SR 520 Bridge Replacement and HOV Program

SR 520, I-5 to Medina: Bridge Replacement and HOV Project Boyer to Delmar Landslide Materials Technical Memorandum

Exhibit A: Extent of Delmar Landslide Area and Debris Removal relative to Future Portage Bay Bridge

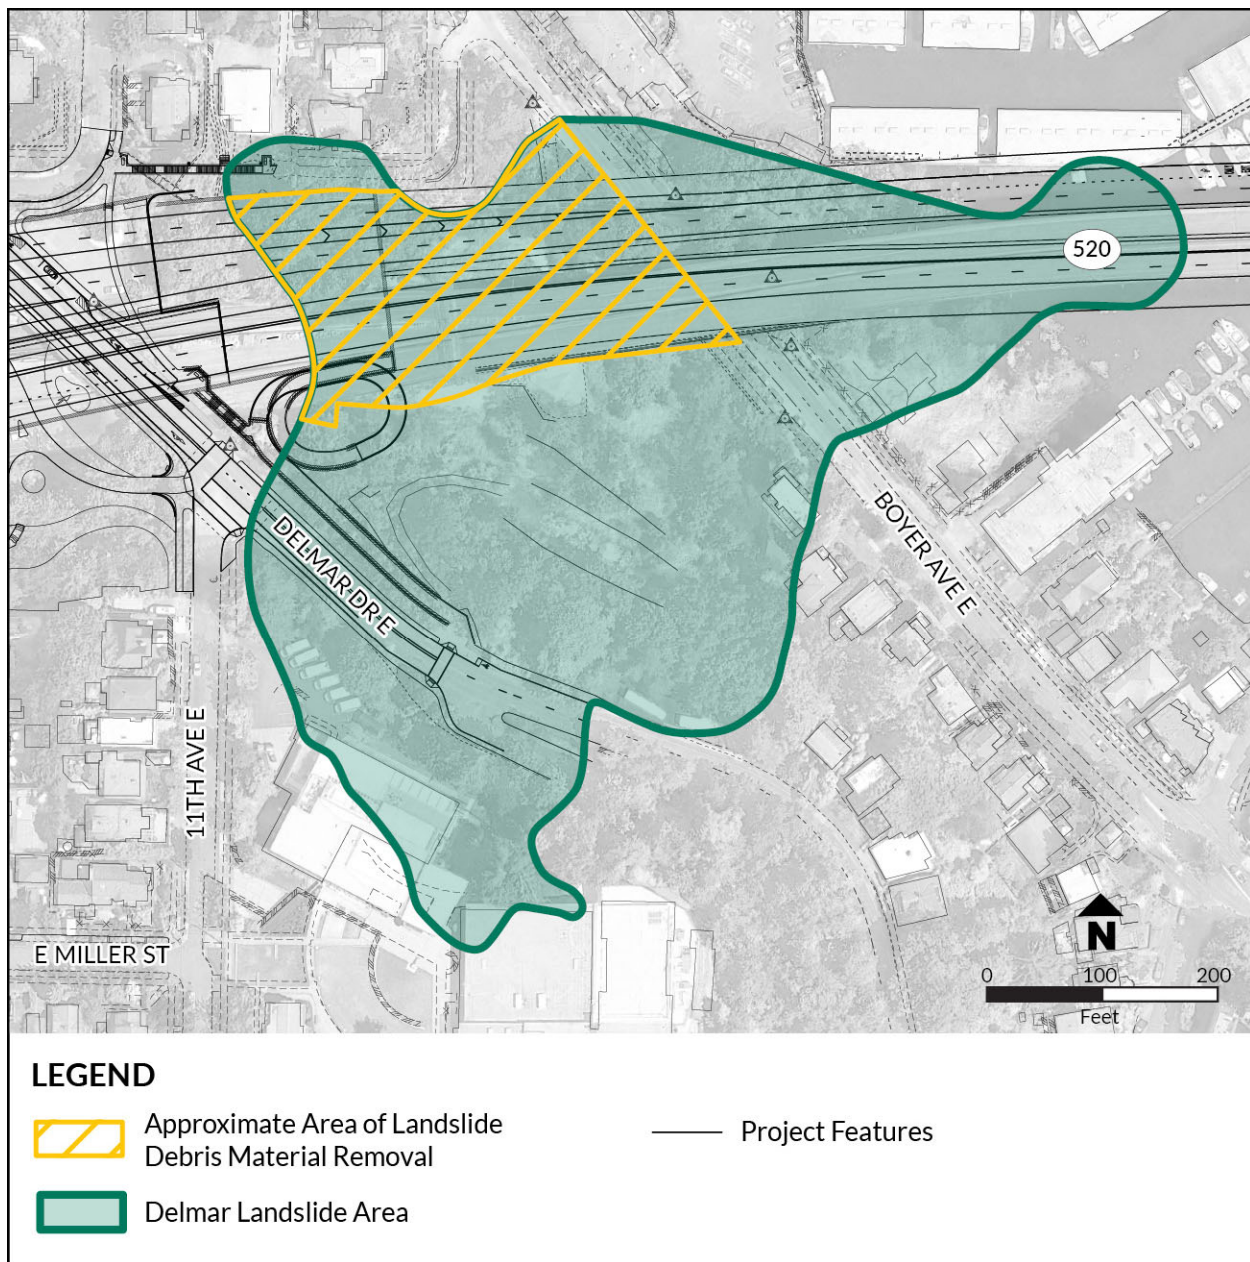
The hillside between Boyer and Delmar Avenues within WSDOT right of way and extending beyond it to the north and south is the site of historic landslides (Delmar Landslide Area, Exhibit A). Debris from previous slides extends from a few feet to a depth of approximately 30 feet across the area. The conceptual design that was developed consistent with the 2011 Final EIS included a system of retaining walls between Boyer and Delmar Avenues to stabilize the Delmar Landslide Area and protect the western abutment and on-land support piers of the future Portage Bay Bridge from further slope instability. The preliminary design retaining wall system is shown in Exhibit B, along with identification of walls proposed for elimination as part of the design modifications that are addressed in this memo. This memorandum evaluates the design refinements for the Delmar Landslide Area compared to the 2011 Final EIS.

Exhibit B: Final EIS Preliminary Design and Retaining Walls Evaluated for Elimination

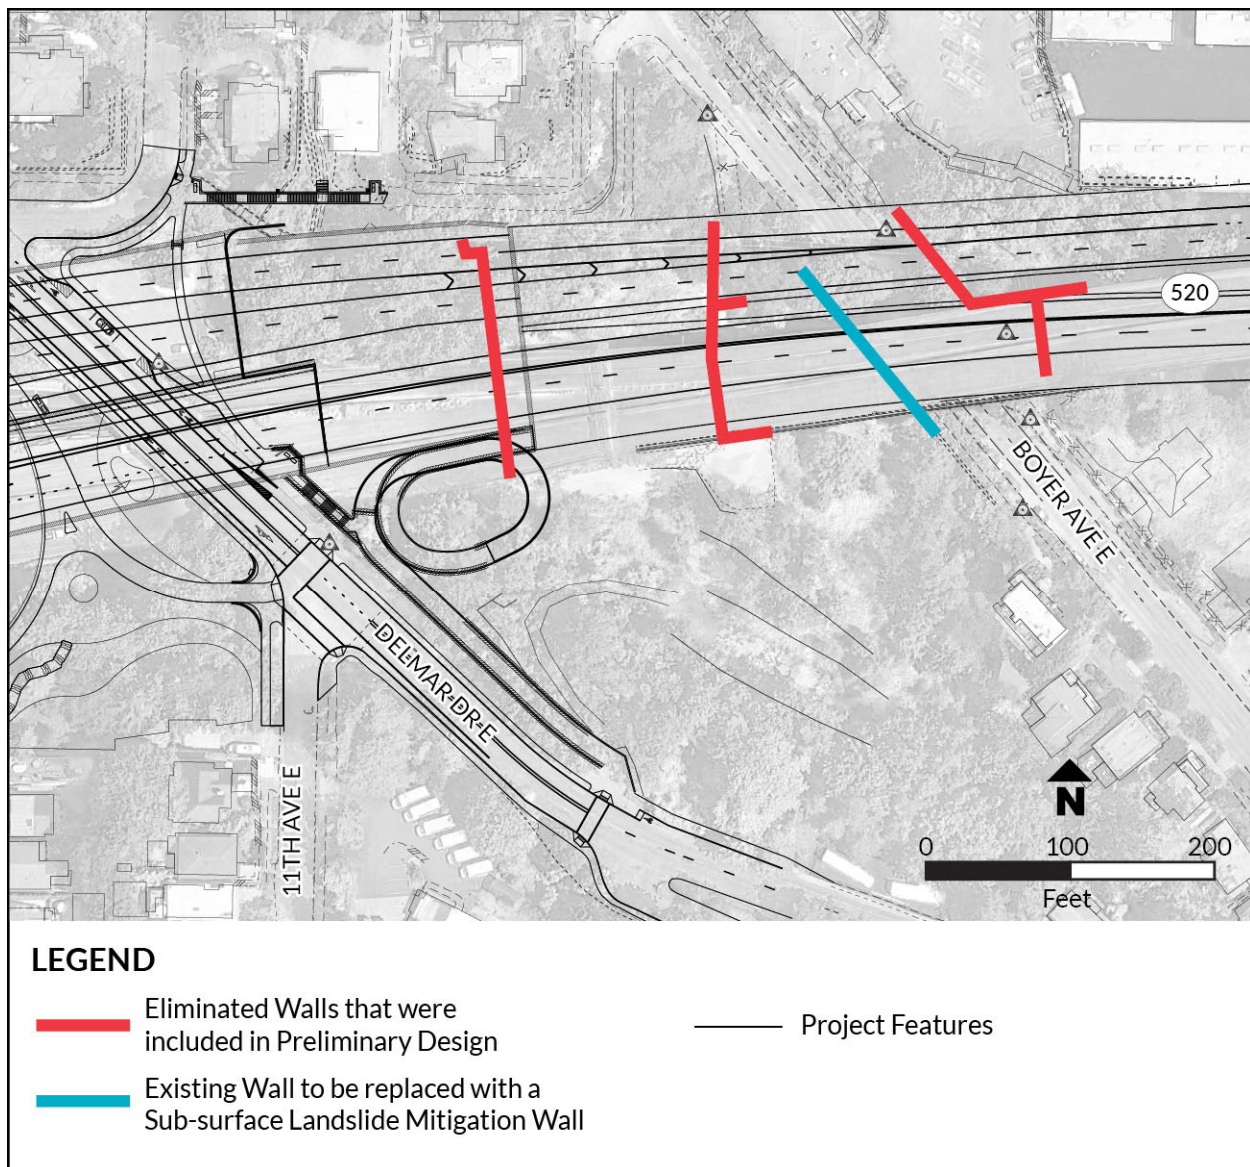
The general proposal is to eliminate the retaining walls identified in Exhibit B and achieve slope stability through removal of unstable materials, slope re-grading, and replacement of landslide materials with stable material. All changed work would be within previously identified areas of construction that were considered in the Final EIS and subsequent NEPA reevaluations.
